SERVICE BULLETIN

Subject: INBOARD-ROLLSTOP JAMMING ON BASEPLATE
Applicable Products: S AND K 5500 SERIES LIFTS
Effective Date: 03-02-06

Figure [1] BASEPLATE

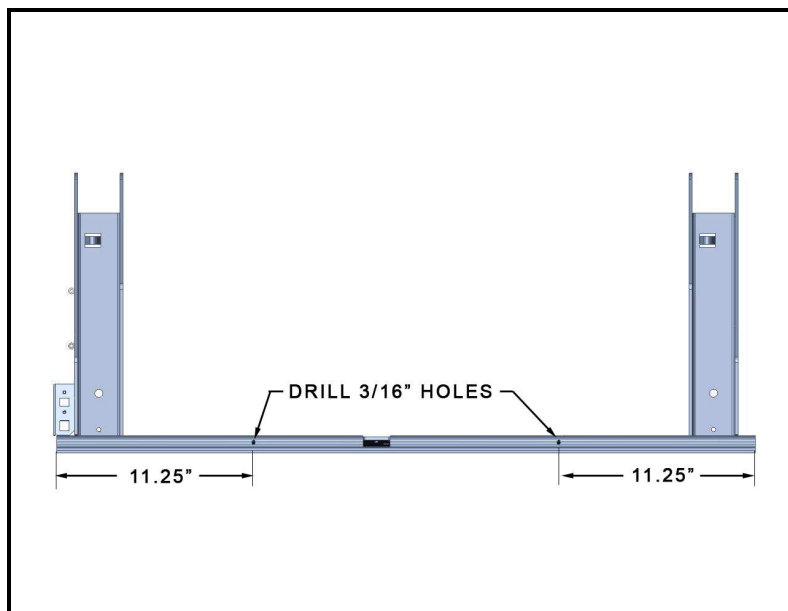
Corrective Action: Install Guide blocks.

- DRILL TWO 3/16" HOLE IN BASEPLATE AS SHOWN.
- USE A STOP ON THE DRILL BIT, SO THE DRILL GOES NO MORE THAN A 1/4" INSIDE THE PLATE.
